HISTORIC AND DESIGN REVIEW COMMISSION

HDRC CASE NO: 2023-280
ADDRESS: 820 N ALAMO ST
LEGAL DESCRIPTION: NCB 452 BLK 30 LOT 6
ZONING: FBZ T4-2, HL
CITY COUNCIL DIST.: 1
APPLICANT: Kent Brittain/Above Ground Design, PLLC
OWNER: Nick Marquez/Barhouse LLC
TYPE OF WORK: Construction of a three-story rear addition
APPLICATION RECEIVED: July 11, 2023
60-DAY REVIEW: September 9, 2023
CASE MANAGER: Jessica Anderson

The applicant requests a Certificate of Appropriateness for approval to construct a three-story rear addition.

18 GATE ELEVATION
1/2" = 1'-0"

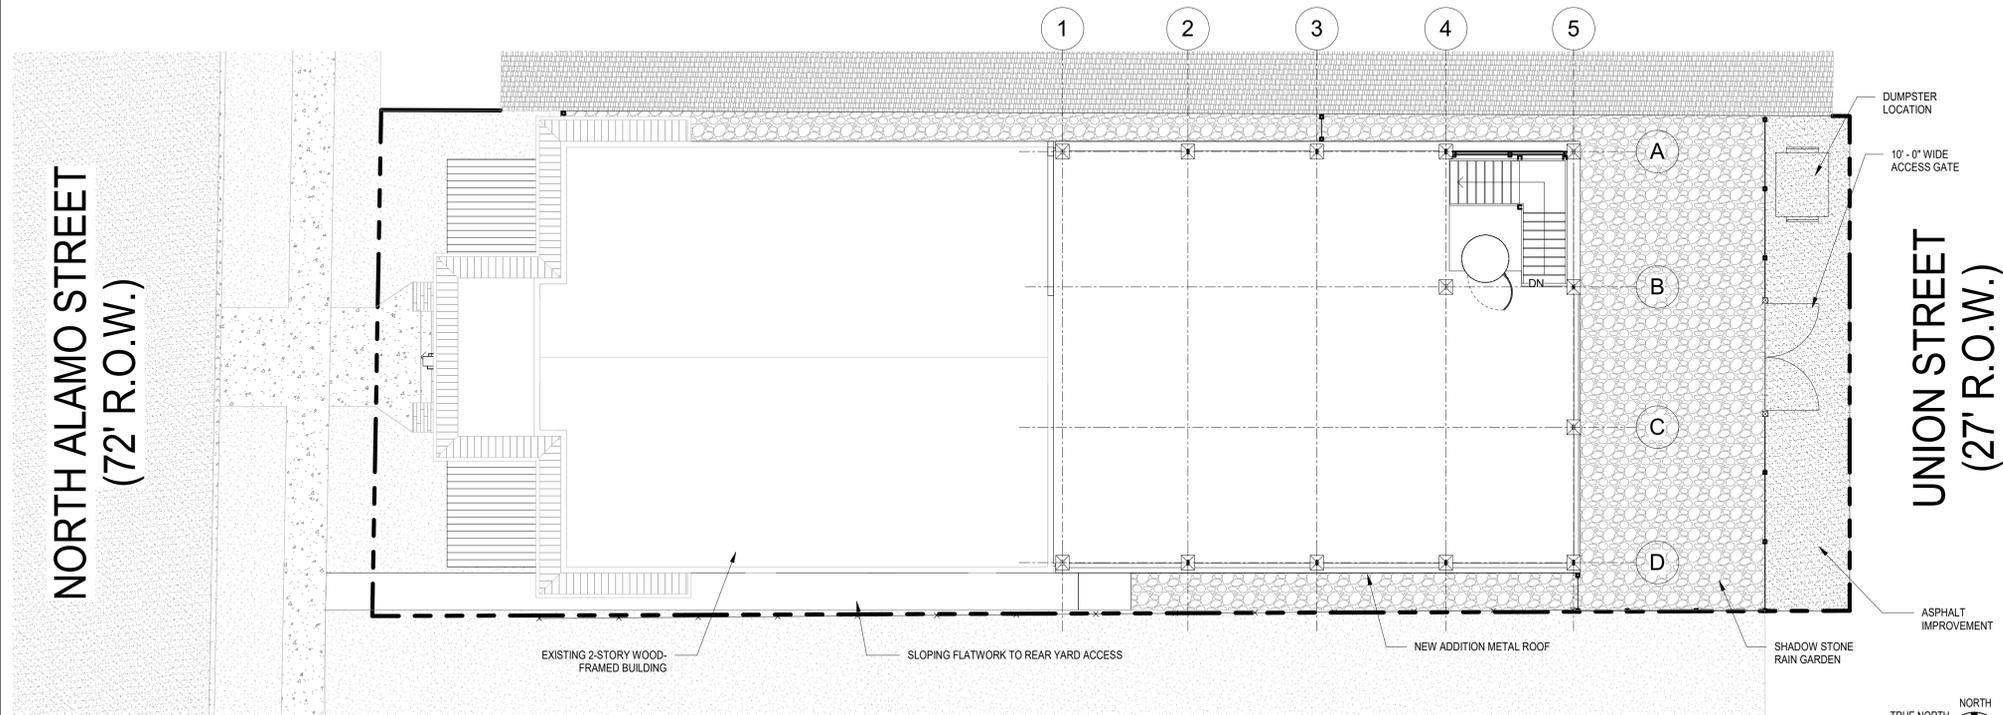
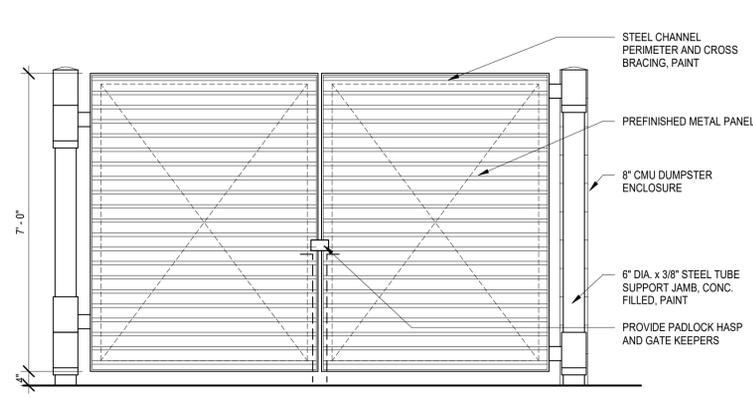
- h. **FENCING:** The applicant requests to construct a fence made of steel pipe posts and corrugated metal panels to enclose the rear yard. Per UDC Sec 35-514(a)(6), fences may not be constructed of sheet, roll, or corrugated metal. Staff finds the applicant must propose a fence that conforms to UDC standards.

ISSUE FOR PERMIT
EXTERIOR ELEVATIONS

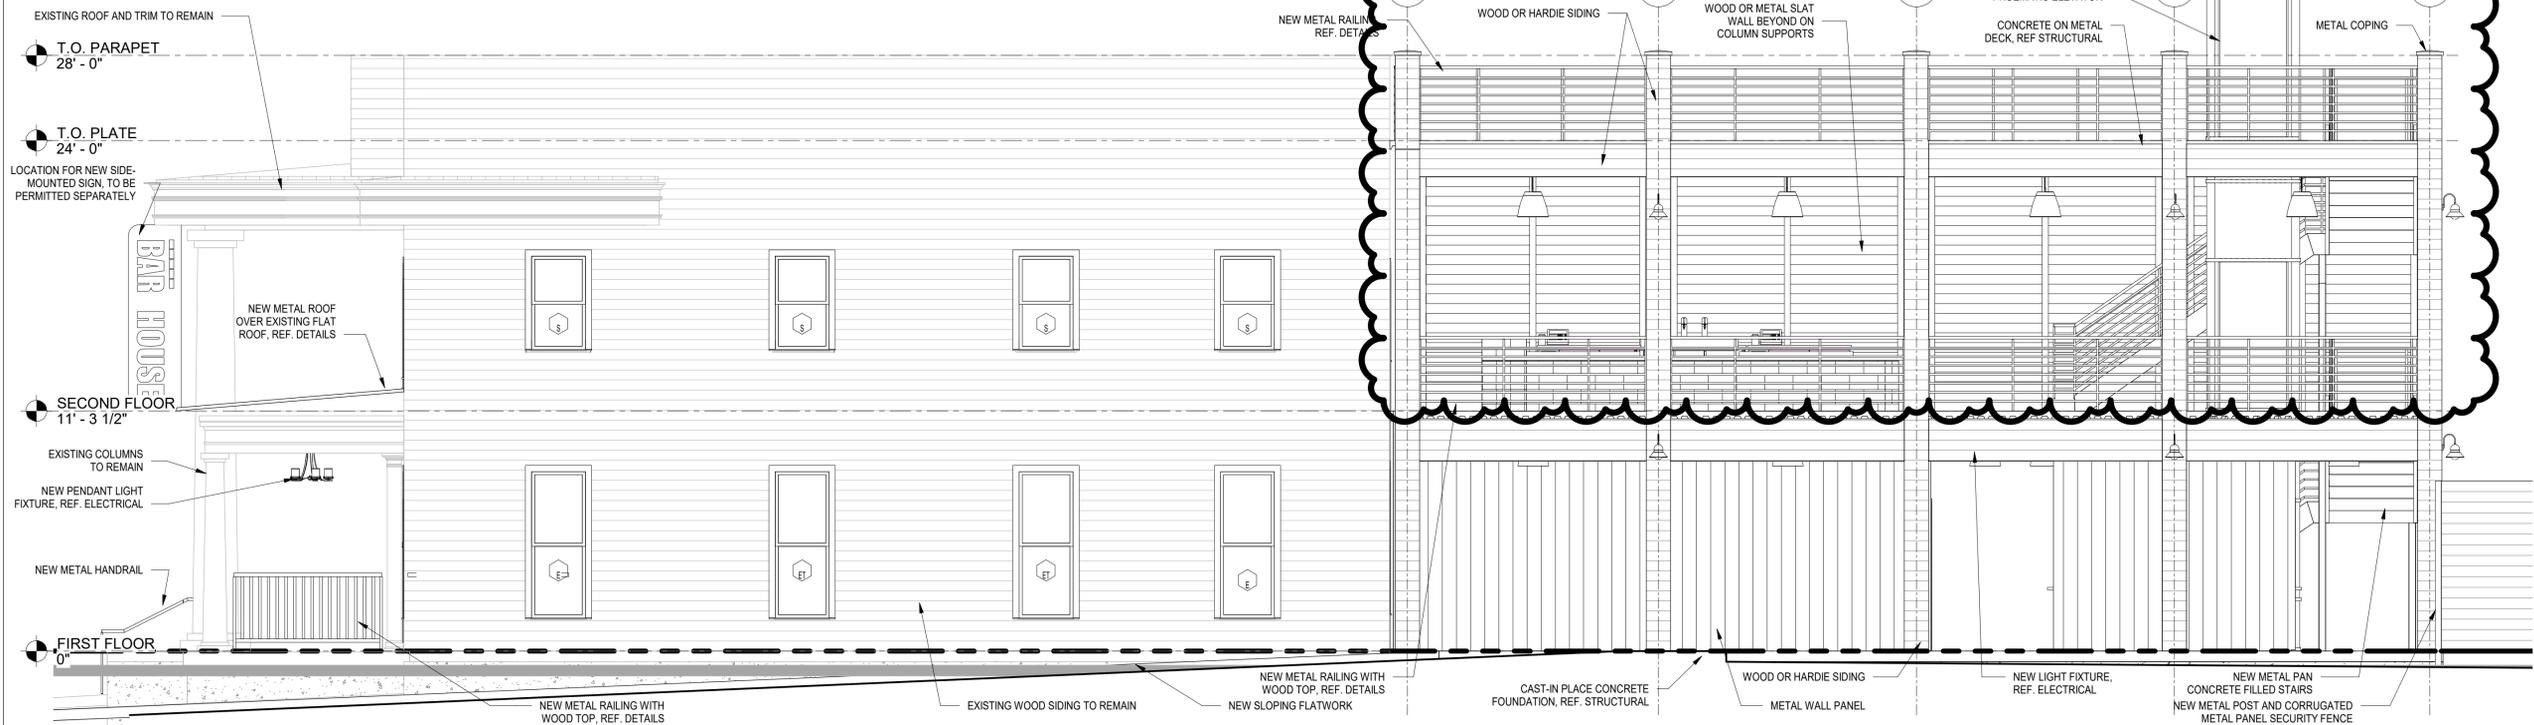
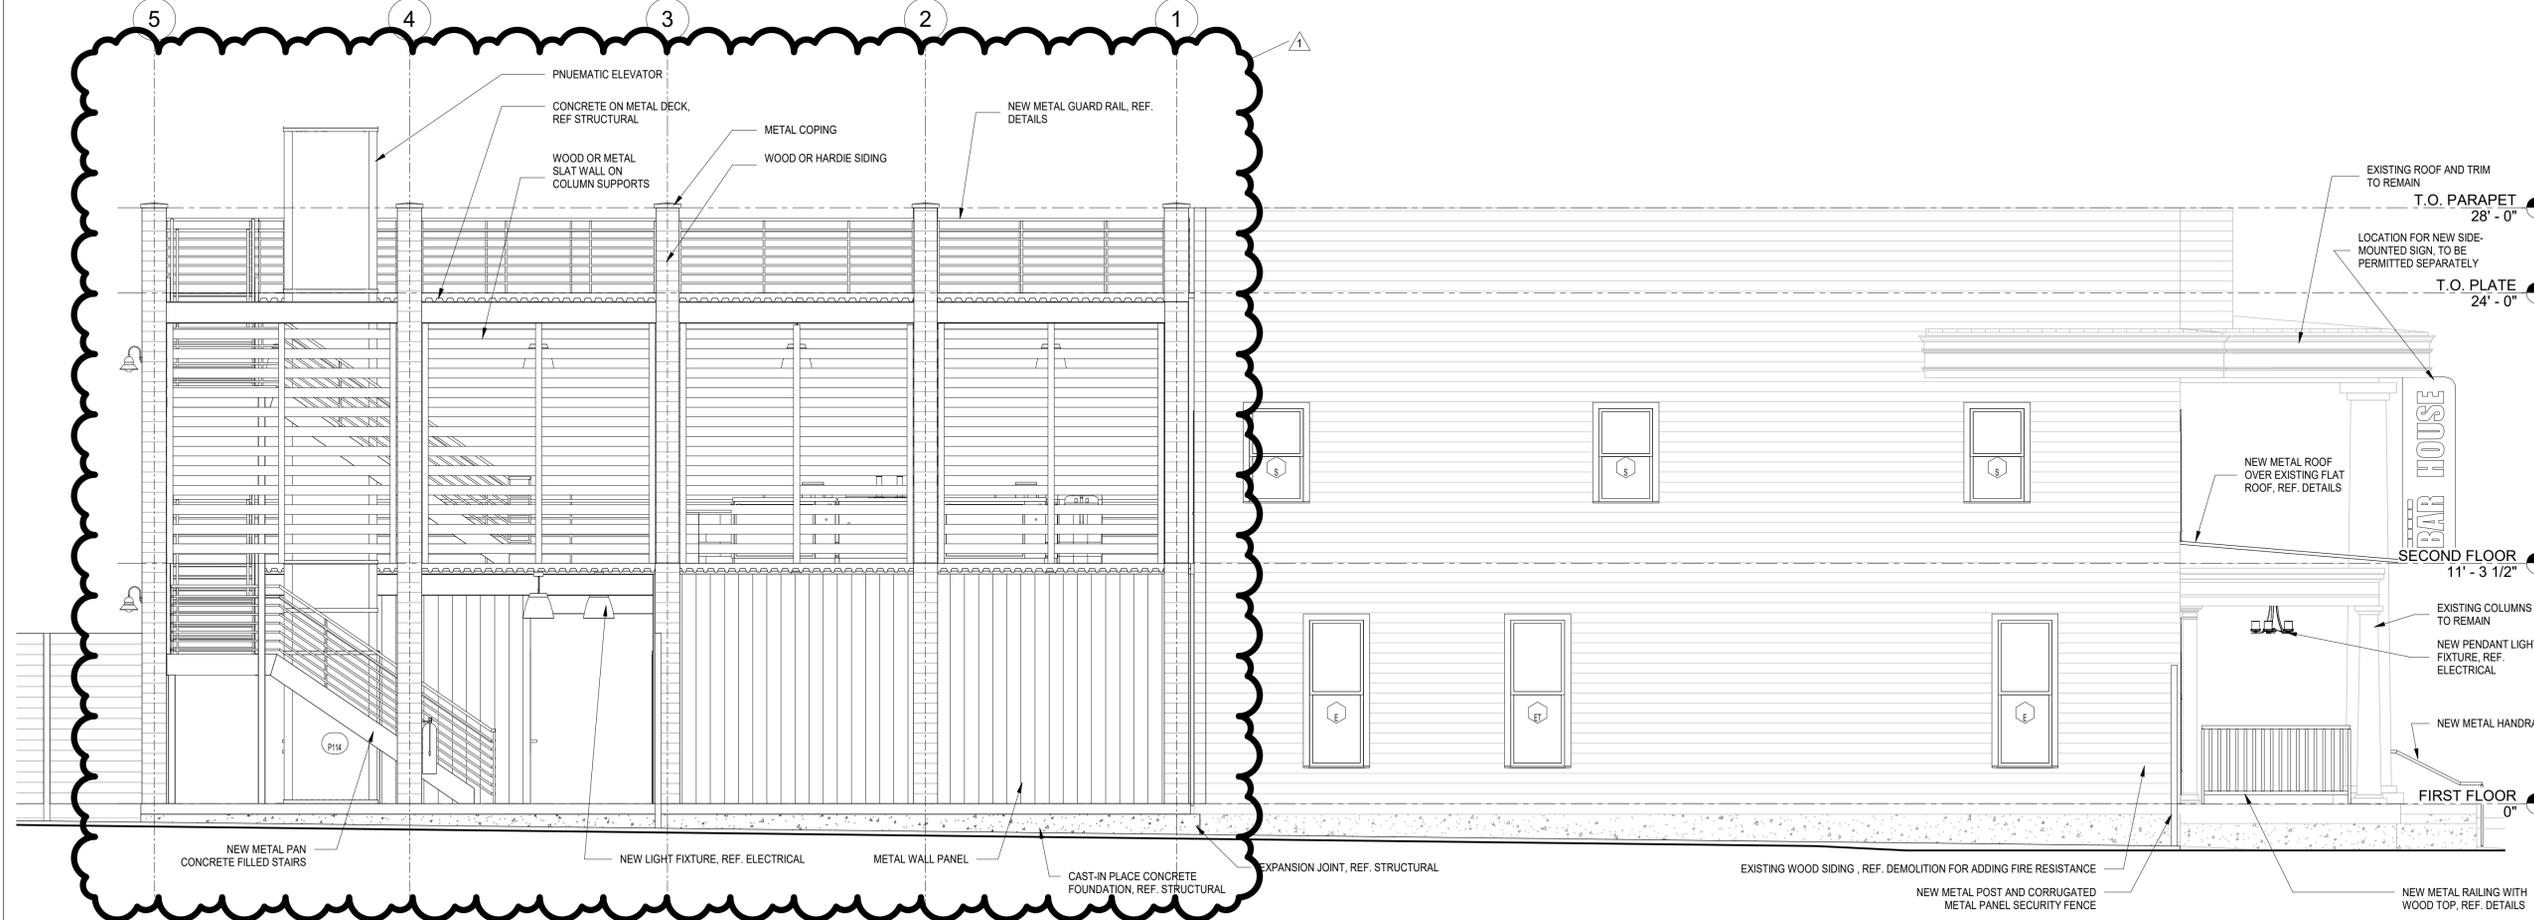
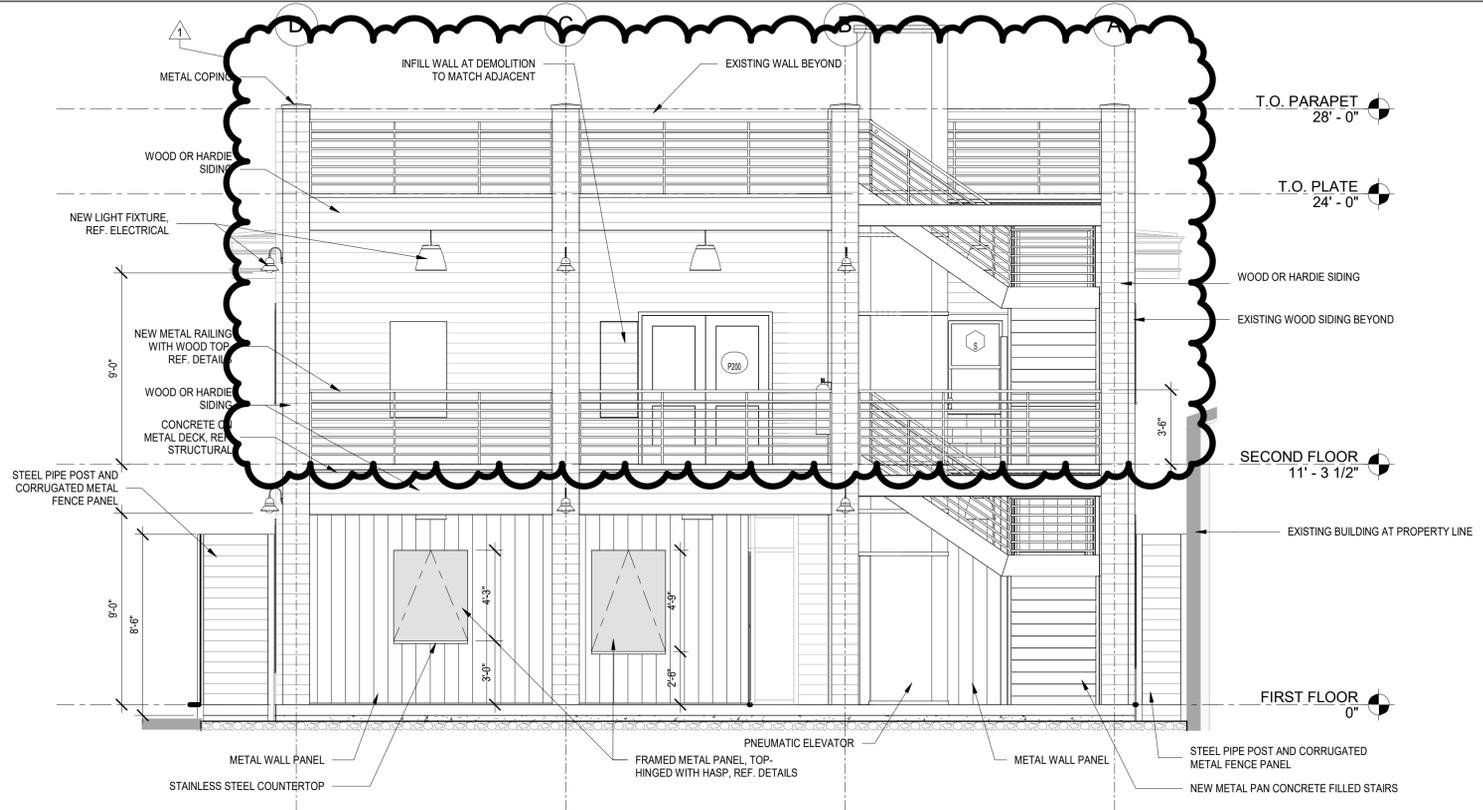
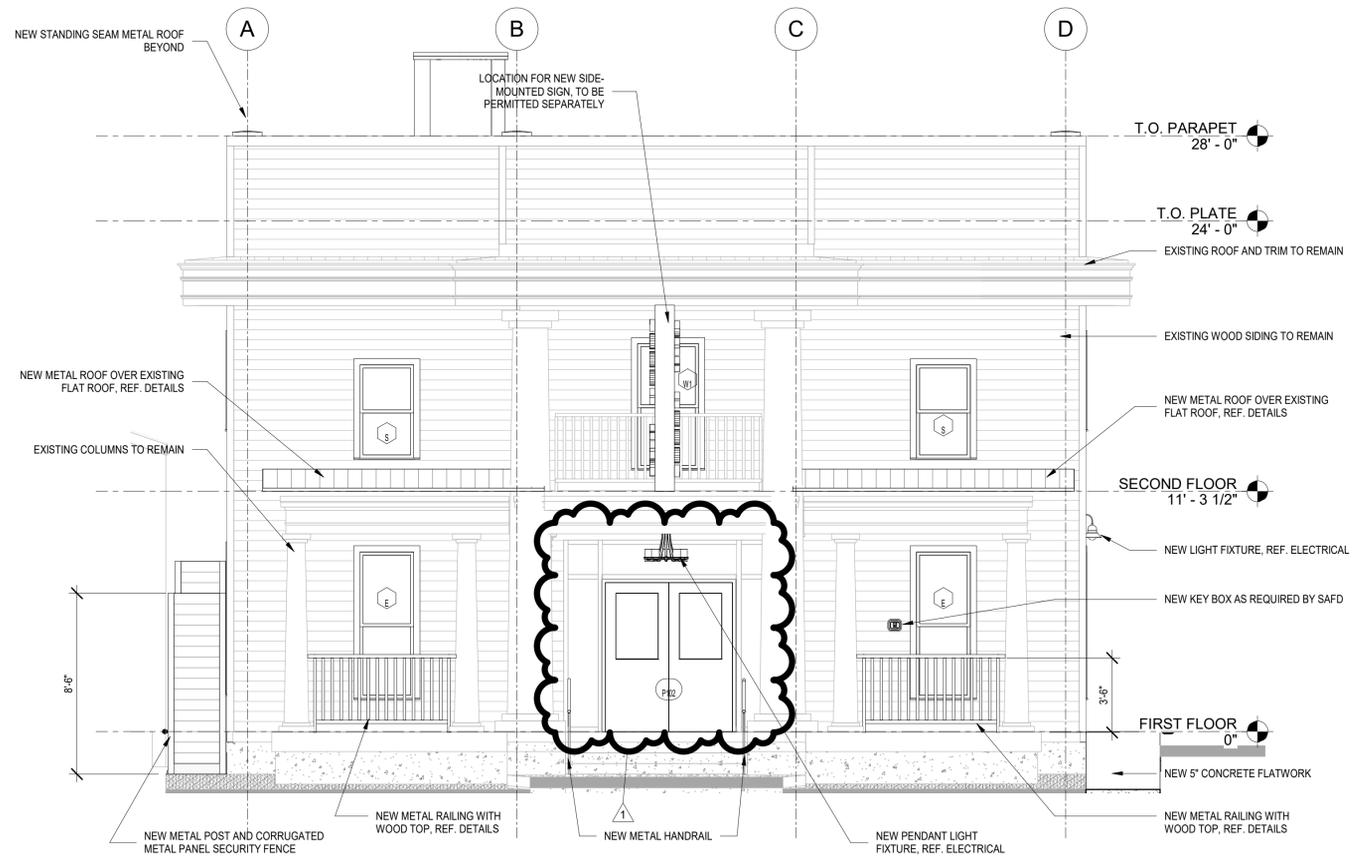
- d. **REAR ADDITION:** The applicant requests conceptual approval of an approximately 1,944-square-foot, three-story rear addition. Renderings show full-height columns clad in wood or Hardie siding extending from the ground to the roof deck, with the bulk of the footprint featuring open-air spaces enclosed on some elevations by wood or Hardie screens, metal wall panels, and wood or Hardie siding. Enclosed spaces are for service and storage use. While staff finds a rear addition generally appropriate, the footprint and massing exceed what conforms to guidelines, as outlined in the next findings.

- f. **MASSING:** The applicant proposes a two-story addition with roof deck. Historic Design Guidelines for Additions 1.B.i says residential additions should be designed to be subordinate to the principal façade of the original structure in terms of their scale and mass. The height of the proposed addition is subordinate to that of the existing house, but does not include setbacks where the addition meets the existing structure. There is, however, a material change between the existing house and the proposed addition. Staff finds the massing of the transition between the existing house and the proposed addition generally appropriate.
